# **Attachment 15 to Item 10.1.1.**

## **Preliminary Bushfire Constraints Analysis**

Our ref: 22SYD3519

**Re: 35 Grose River Road, Grose Vale - Preliminary Bushfire Constraints**

Figure 1: Revised structure plan

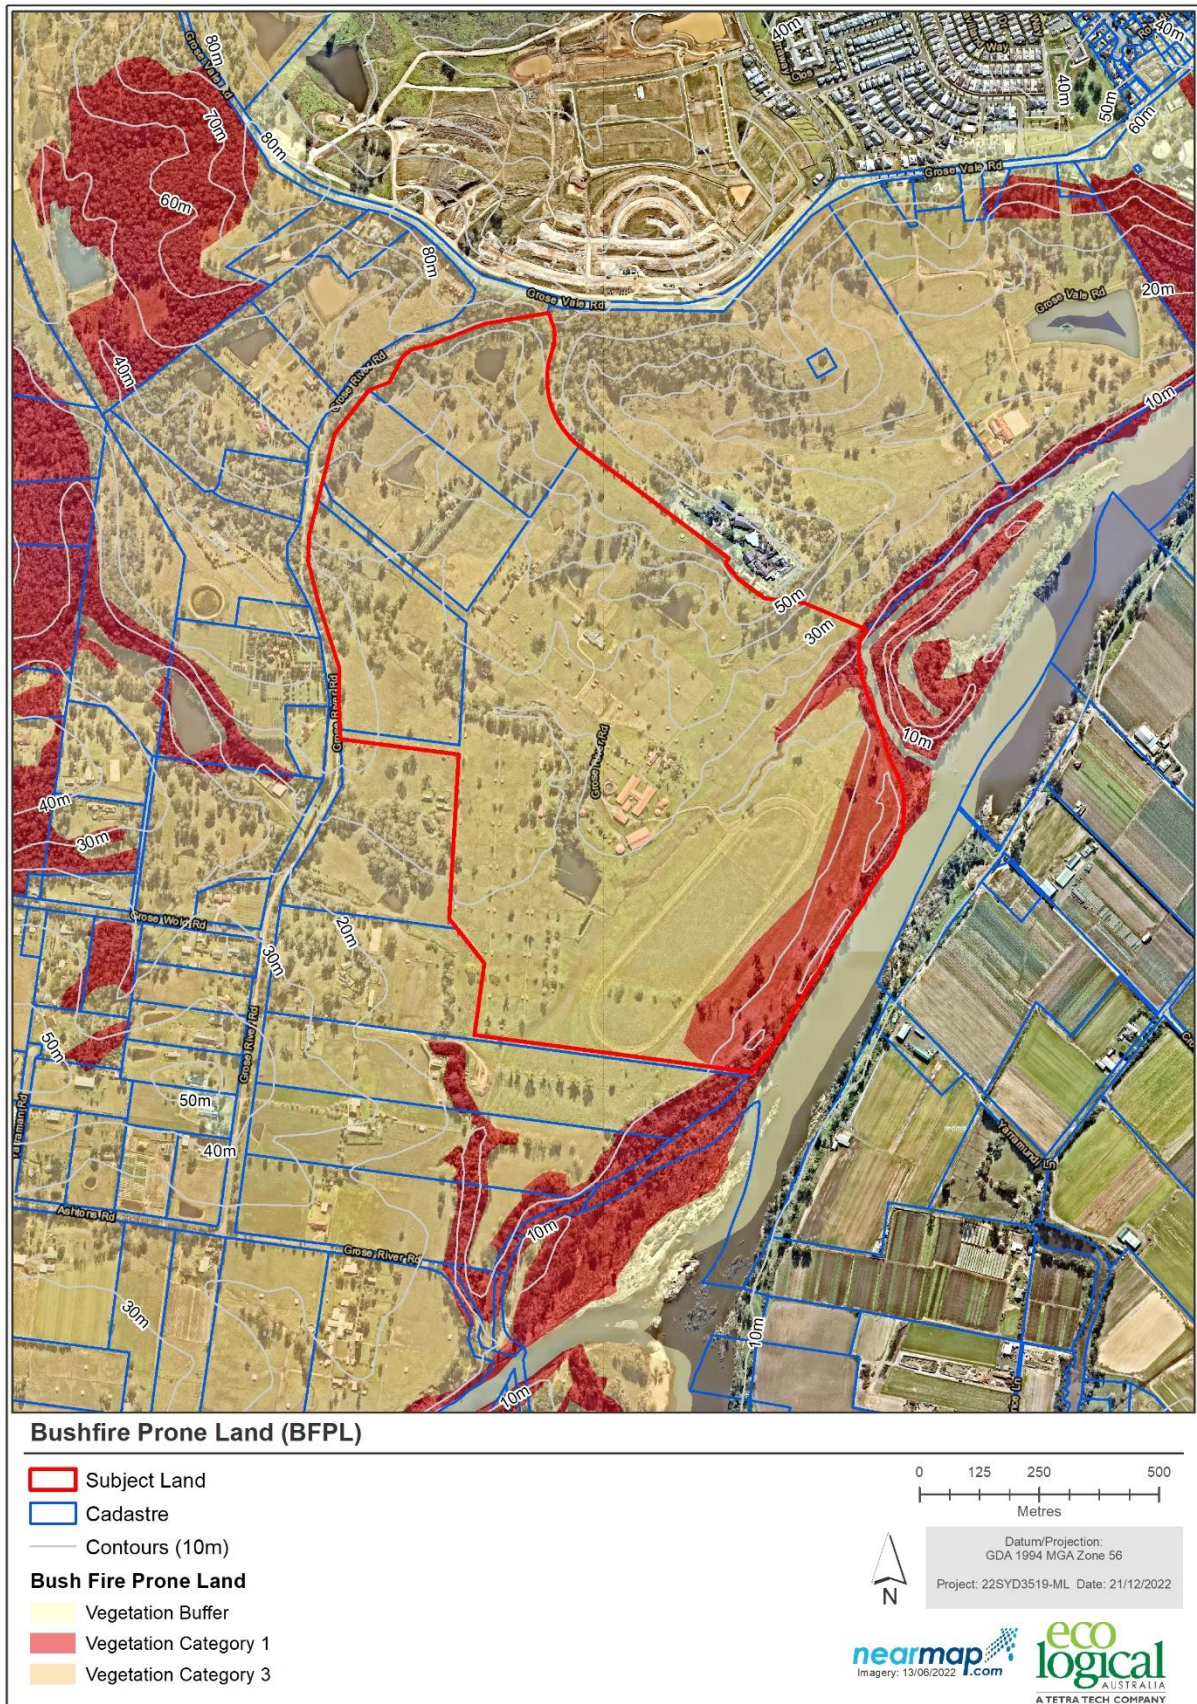
This assessment has been updated from the previous constraints advice issued on 30 March 2023 due to the provision of a revised concept Masterplan

Future buildings will need to be located outside of any APZ and the final structure plan should facilitate this. Some lots are constrained by APZ setbacks, particularly in relation to the Special Fire Protection Purpose (SFPP) APZ which may be required for the proposed cluster housing, central hub and tourism hubs. Figure 3 identifies the SFPP APZ to the assessed bushfire hazard vegetation adjacent to the proposed seniors living site. SFPP APZ has only been shown in those areas as indicated by the structure plan. If this changes then the map and advice will need to be updated.

It is recommended that the final concept design for Planning Proposal submission considers the APZ requirements.

Figure 3: BHA and indicative APZ

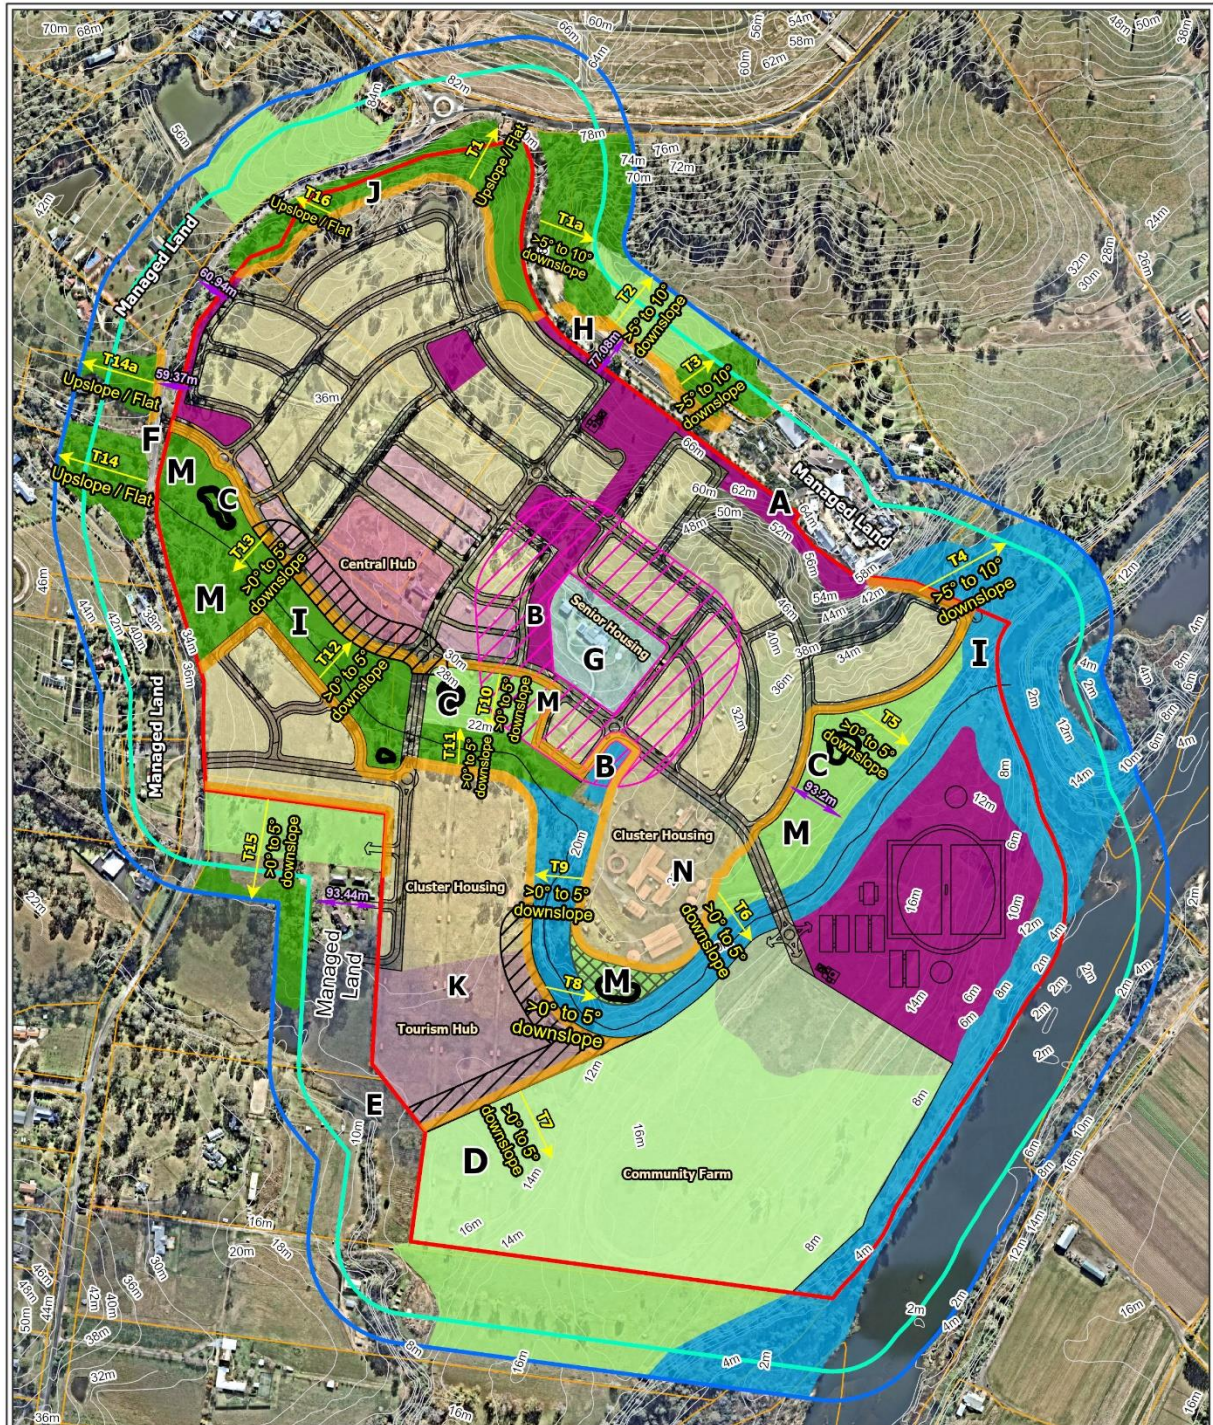
As shown in Figure 3, there is bushfire prone vegetation external to the subject land, a revegetated riparian corridor proposed within the subject land and potential grassland hazard to the southeast. The majority of the existing vegetation within the subject land is grassland with some small areas of grassy woodland and existing riparian vegetation which is to be retained and enhanced throughout the site.

The effective slopes under the bushfire hazards are identified as either 'all upslope and flat land', '>0-5 degrees downslope' and '>5-10 degrees downslope' across and external to the subject land. Figure 3 shows where this slope assessment occurs.

The widths of the required APZ for future residential and SFPP development were determined using the vegetation and slope data identified above and Tables A1.12.1 and A1.12.2 of PBP. Table 1 details the results of this assessment which are also shown in Figure 3.

Future residential lots constrained by APZ requirements include those in the north, northeast, and adjacent to riparian corridor hazards where no perimeter access is proposed.

- As shown in Figure 3, some lots are constrained by PBP APZ requirements, and it is recommended that perimeter roads are provided to the bushfire hazard vegetation, or lot sizes are increased to accommodate appropriate APZ to achieve the required residential APZ setbacks.

Map Key	Comment	Recommendation
A	This area is adjacent to a hospital and has been assessed as managed land	This area must be managed to APZ standards to avoid any increased bushfire risk on adjacent SFPPP development
B (south)	This section of the riparian corridor has been assessed as forested wetlands.	This area must be managed to APZ standards to ensure there is capacity for SFPP development (seniors housing)
B (west)	This section of the riparian corridor has been assessed as managed land.	This area must be managed to APZ standards to ensure there is capacity for SFPP development (seniors housing)
C	Drainage areas can accommodate APZ requirements, however should these constitute a hazard, there will be BAL construction requirements	Confirmation of drainage basin vegetation management needed
D	Community Farm -assessed conservatively as grassland	Pending typology of this area perimeter roads would be required between this hazard and adjacent development

E	Has been assessed as managed land	Confirmation required. If unable to be confirmed
F	Existing road provides APZ for external hazard in this area	
G	To avoid APZ impacts and BAL construction requirements on Senior Housing, surrounding areas have been assessed as managed land	Areas B, G and C within 100m of the seniors housing must be managed to APZ standard to ensure there is capacity for SFPP development (seniors housing)
H	Existing road provides APZ for external hazard in this area	
I	Riparian corridor assessed as 0-5 downslope to south west and 5-10 downslope to south east	Confirmation required of final slope required assuming earthworks.
J	This areas has been assessed as a hazard	Perimeter road should be provided
K	No perimeter access adjoining riparian corridor or community farm	Perimeter access to be provided
M	Consideration to access to the hazard in these areas	Access for firefighting purposes should be provided along the riparian corridor, and perimeter roads provided where this adjoins development

N	APZ requirement based on forested wetland hazard	Perimeter road required. If SFPP land uses then additional APZ requirements will apply

- Perimeter roads between any future development and the identified bushfire hazard(s) is a requirement of PBP and the layout should be redesigned to facilitate this.

Opportunities exist to refine the preliminary concept plan to meet all the requirements of PBP by implementing the recommendations above and the additional commentary provided in Table 2 below.
